Subject: Dresden Station Units 2 and 3  
Quad Cities Station Units 1 and 2  
Response to Request for Information  
concerning Fire Protection Safe  
Shutdown Analysis  
NRC Docket Nos. 50-237/249/254/265

Enclosure 1

Enclosure 2

Figure 8.2.3 Auxiliary Electrical System - 4160 Volt and 480 Volt

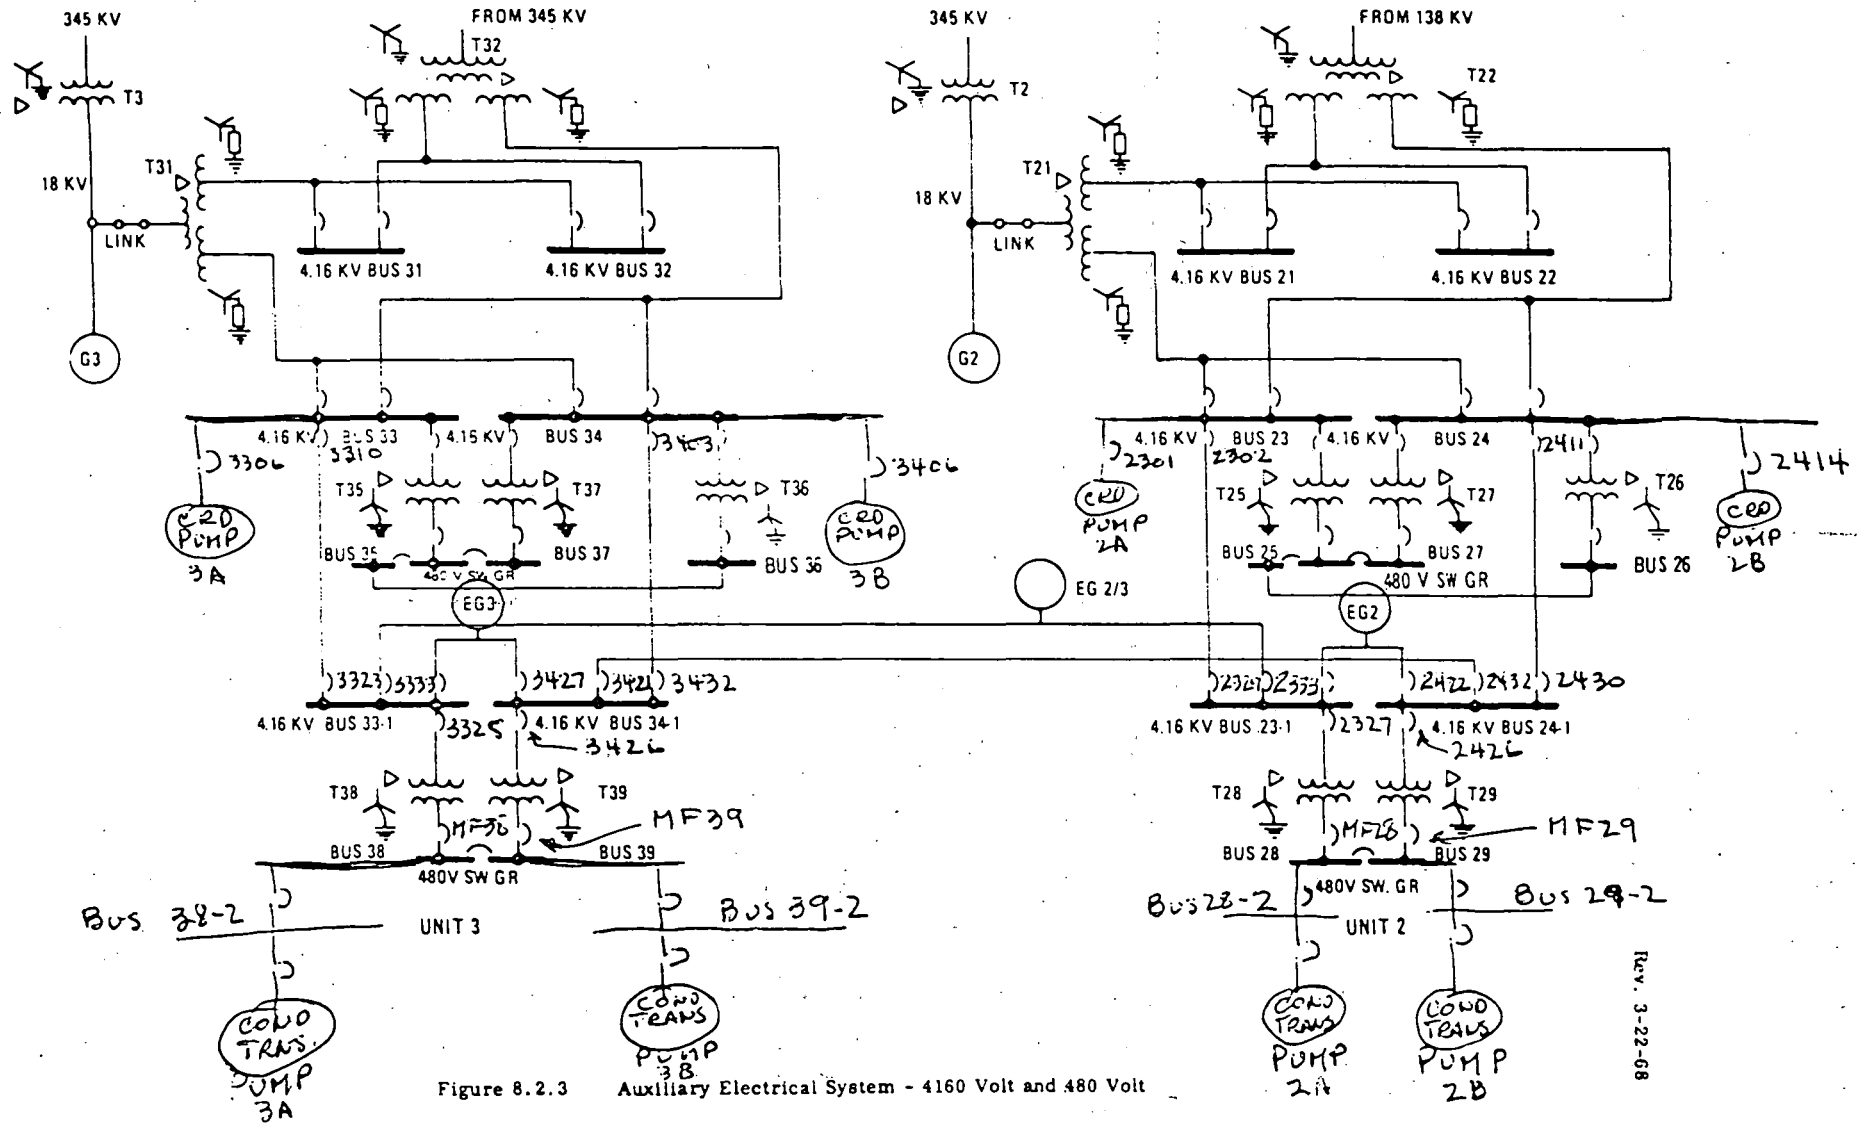
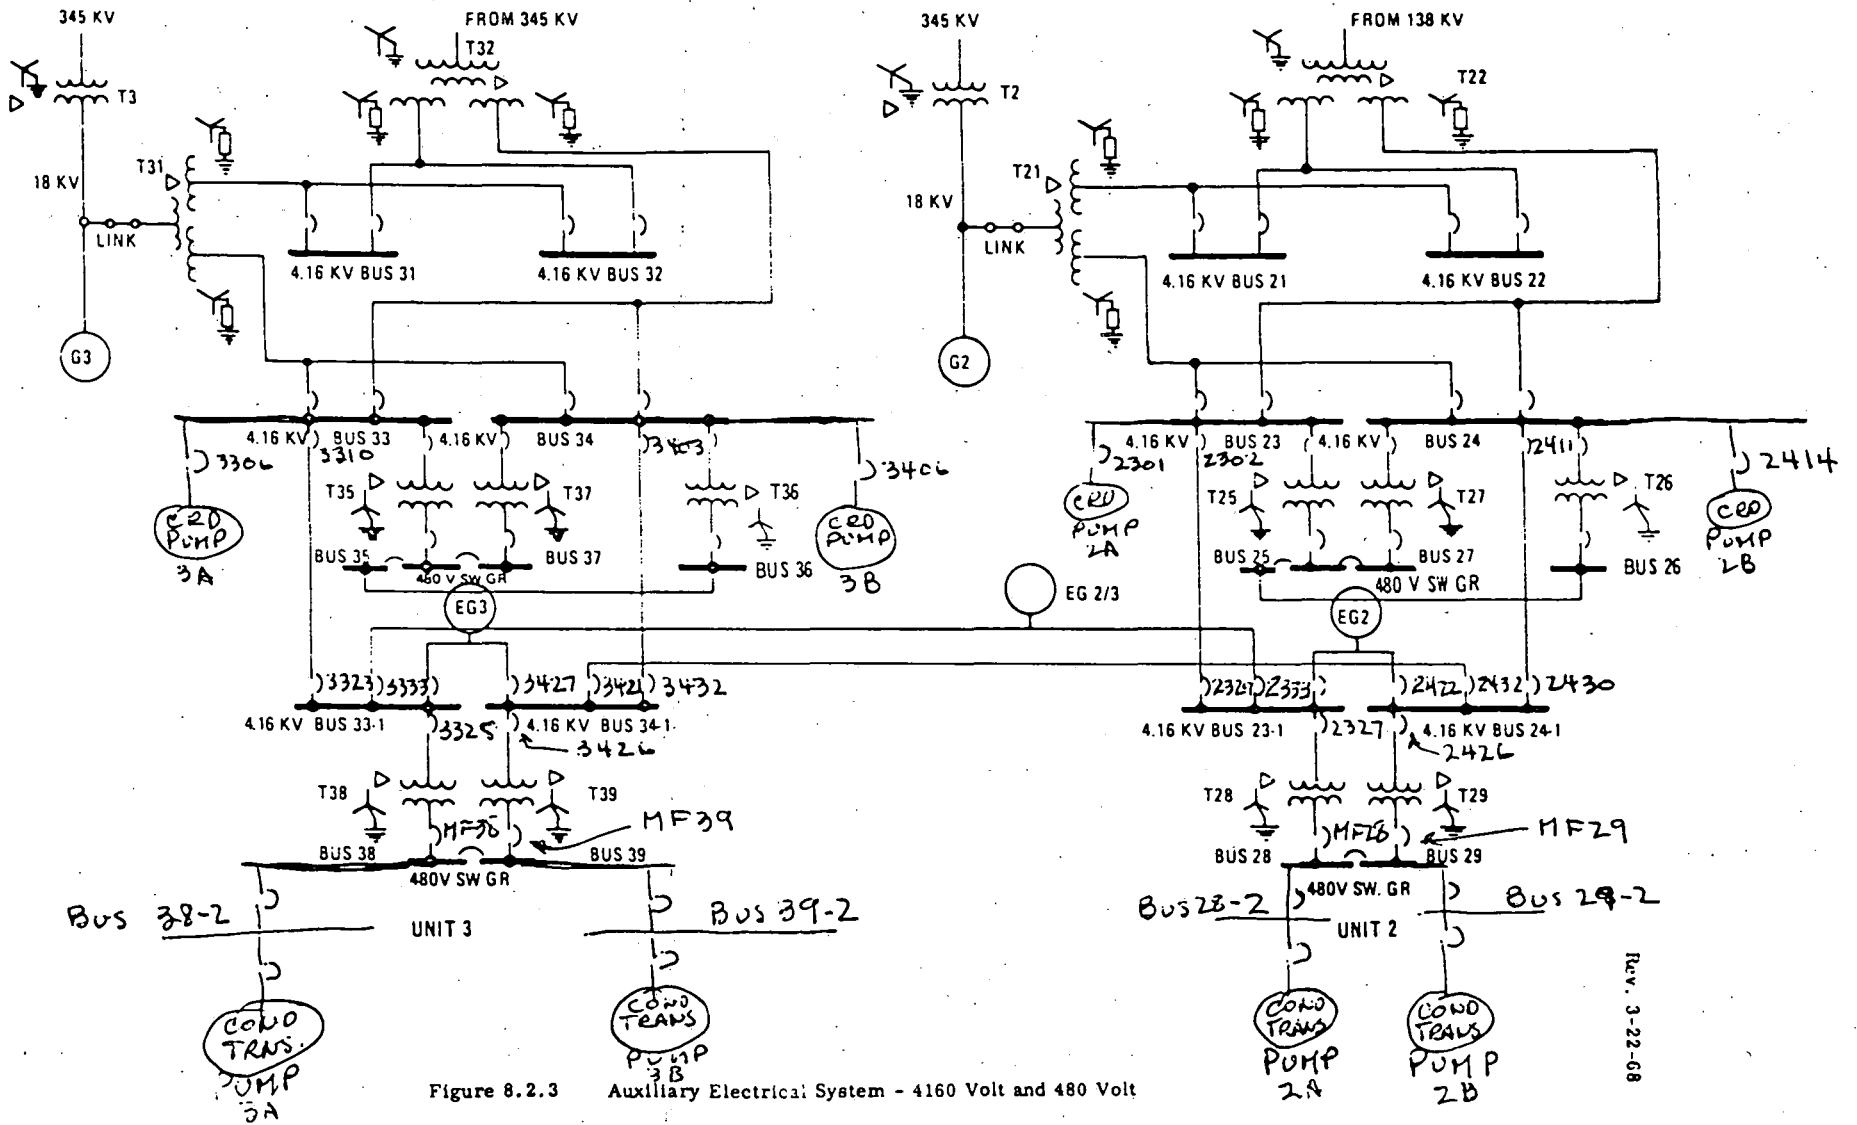
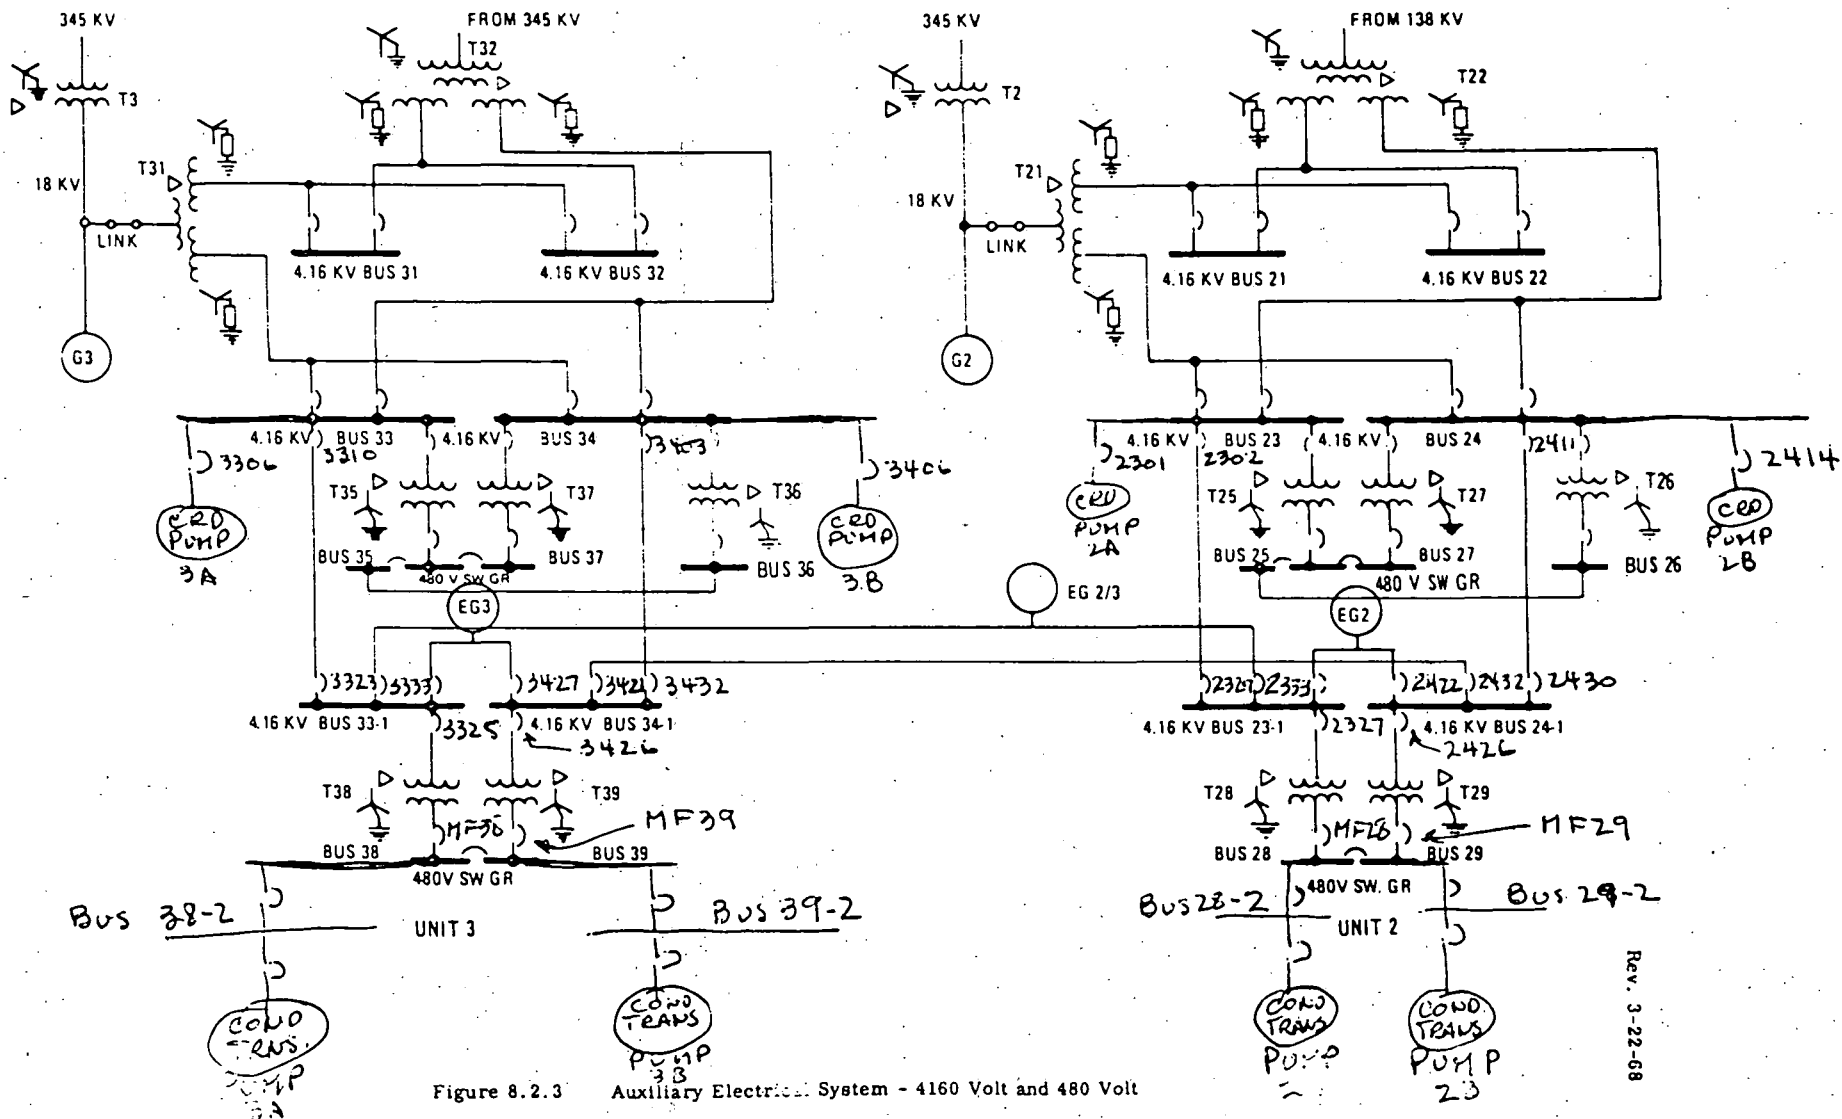
Demonstrate that alternate shutdown power sources, including all breakers, have isolation devices on control circuits that are routed through the area to be avoided, even if the breaker is to be operated manually.

The equipment that would be needed to provide for a safe shutdown for fire is identified in the Dresden 2/3 Safe Shutdown Analysis and its supplements. This equipment is:

The power supplies necessary to provide power to these pumps are:

1. 4KV bus supply from Diesel Generators.
2. 4KV bus supply from opposite unit.
3. 4KV bus supply to Control Rod Drive Pumps.
4. 4KV bus supply to the 480 Volt bus supply to the MCC feeding the Condensate Transfer Pumps.
5. 480 Volt supply to the Condensate Transfer Pumps.

Copies of the following drawings provide the details of the isolation devices of control circuits for the power sources identified above.
